GRADING & DRAINAGE PLAN

<b>Clark Consulting Engineers</b>			
19 Ryan Road Edgewood, New Mexico 87015 Tel: (505) 281-2444 Fax: (505) 281-2444			
DATE	REVISION	TRACT C-1 BLOCK 1, ALBUQUERQUE, NEW MEXICO	
		130 COORS BOULEVARD, NW	
		TAM LE SALON	
		<b>Grading &amp; Drainage Plan</b>	
DESIGNED BY: PWC	DRAWN BY: CCE	JOB #: VAN-HUINH	1 OF 1
CHECKED BY: PWC	DATE: 5/18/15	FILE #: G/D

**Re: Tam Le Salon  
130 Coors Blvd NW  
Grading and Drainage  
Engineers Stamp Date 8/10/2015 (K10D047)**

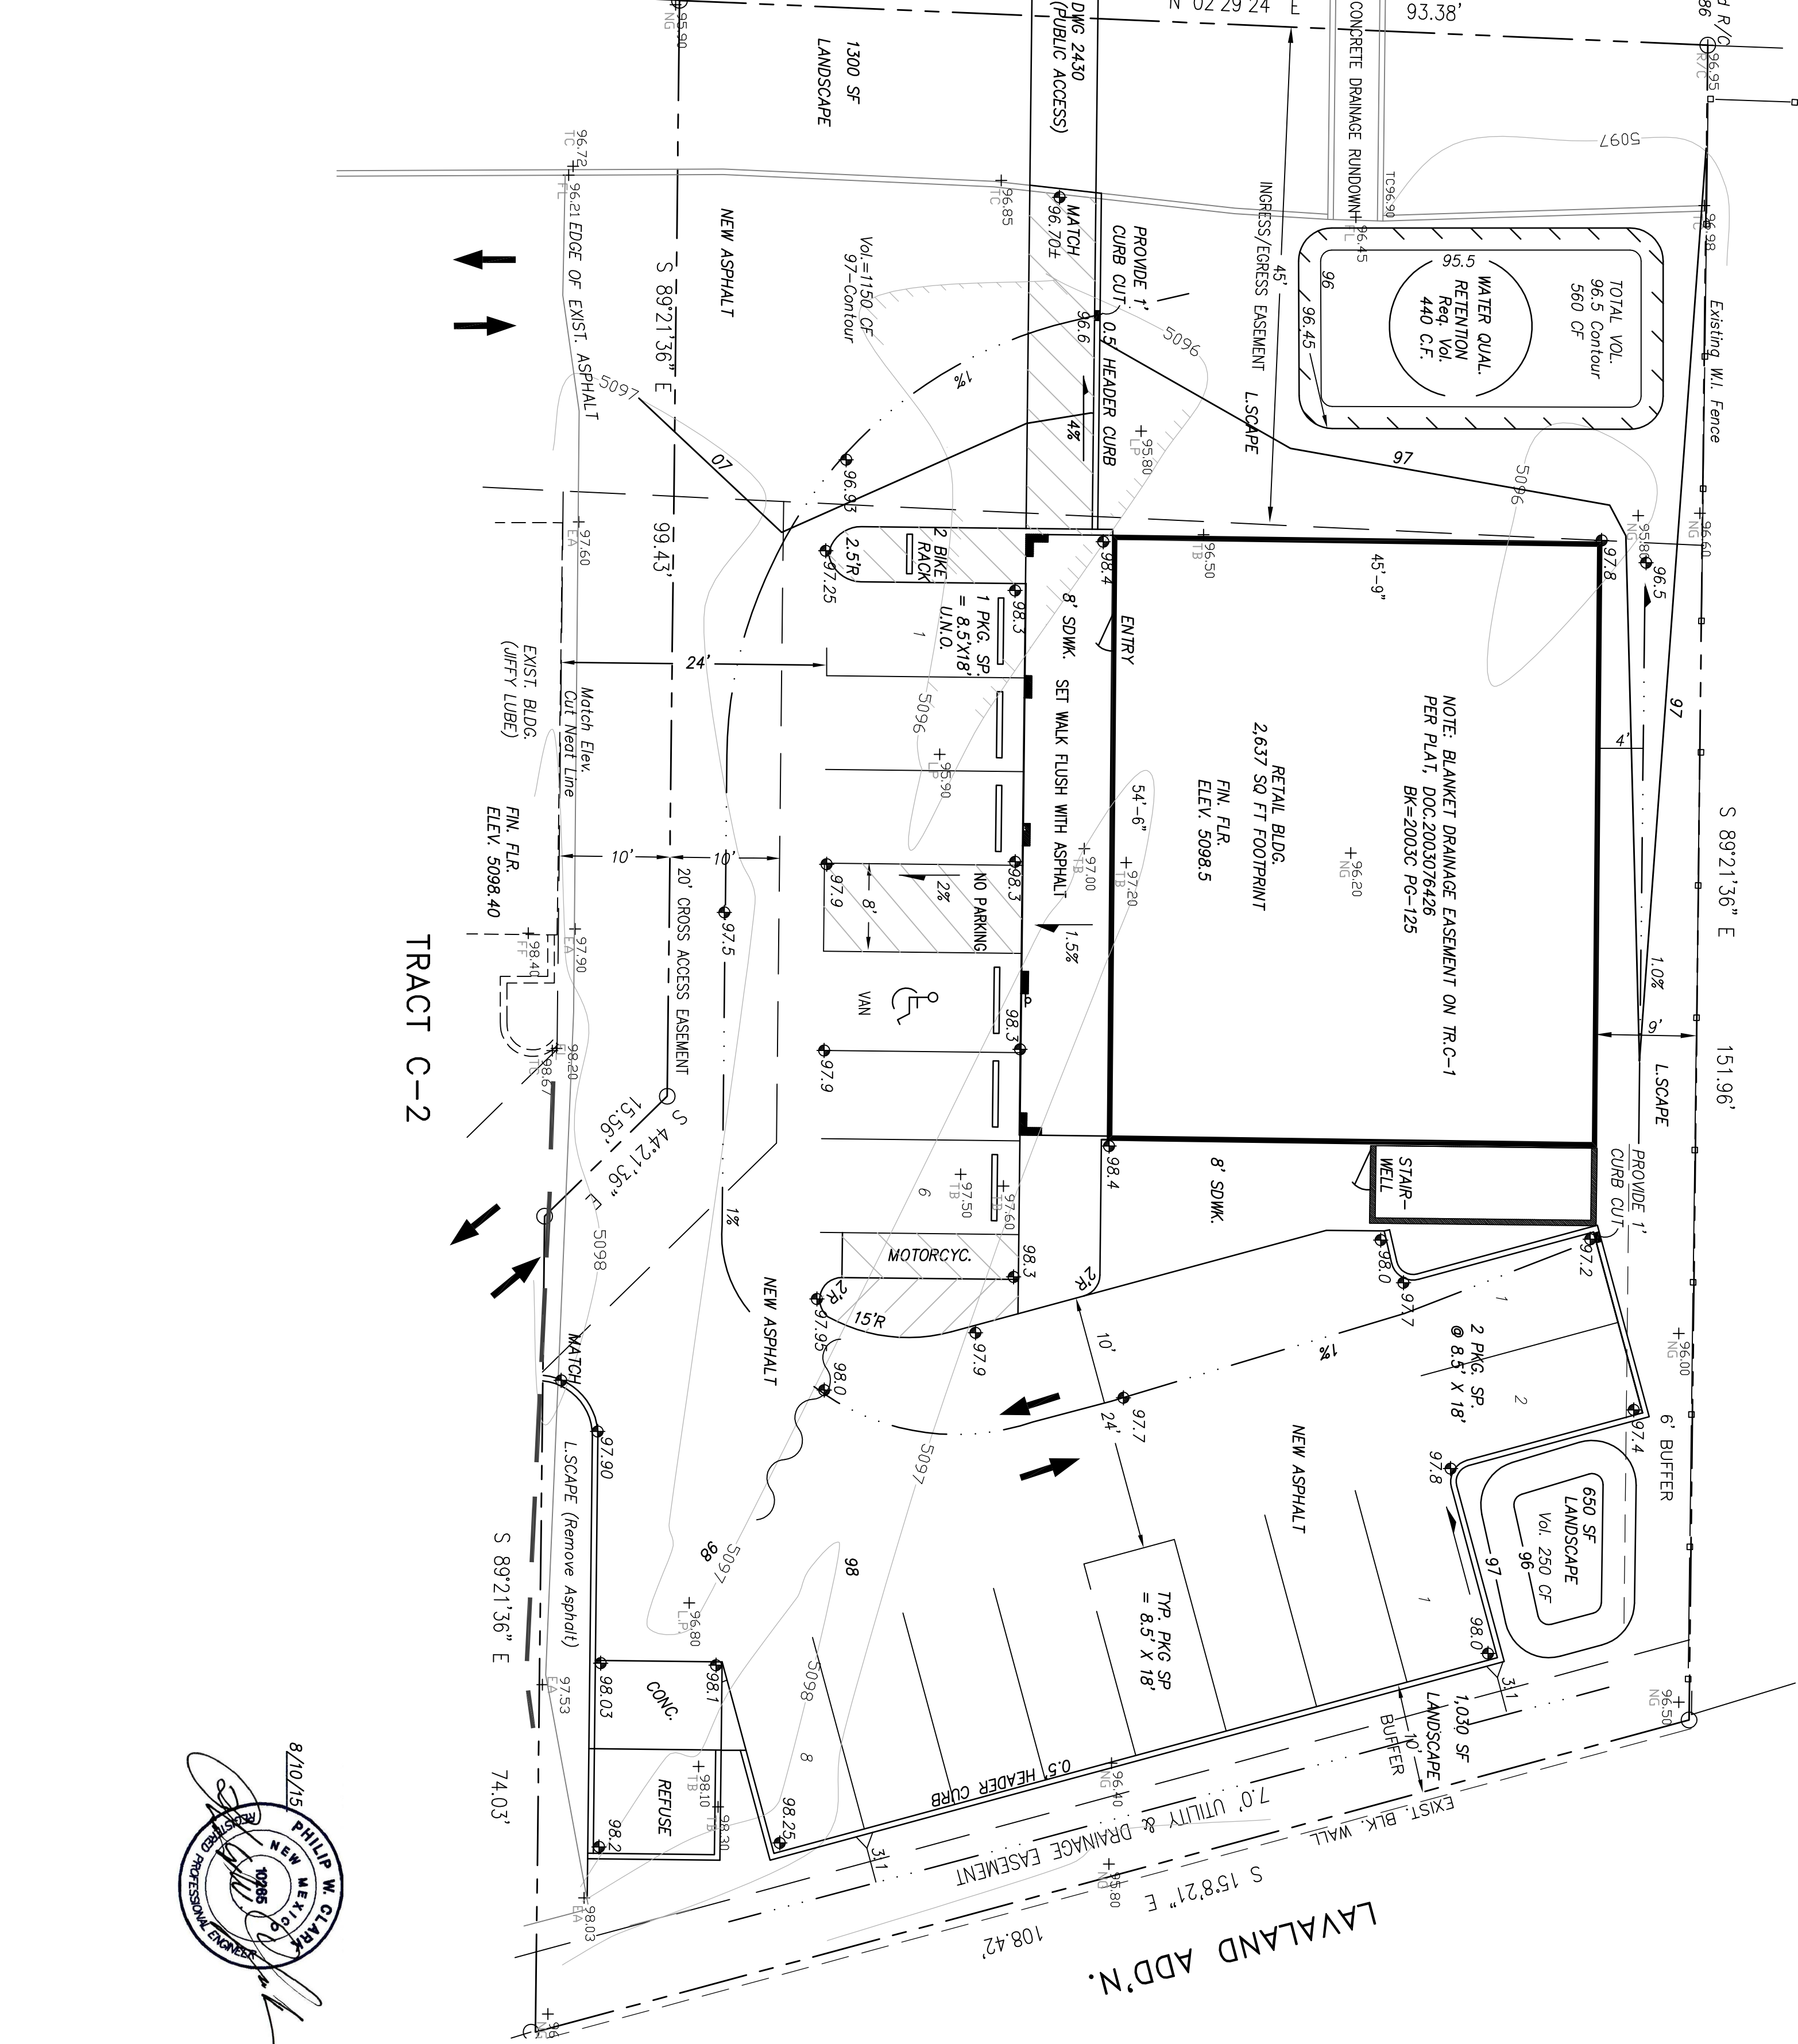
Based upon the information provided in your submittal received 8/11/2015, the above referenced Grading and Drainage Plan cannot be approved for Grading Permit or Building Permit until the following comments are addressed.

- Provide roof flows.
- Provide flow calculations for the concrete drainage rundown.
- Verify if the system in the sidewalk is a sidewalk culvert or pvc? Provide calculations for either one.
- An access agreement must be provided from the owners to the south.
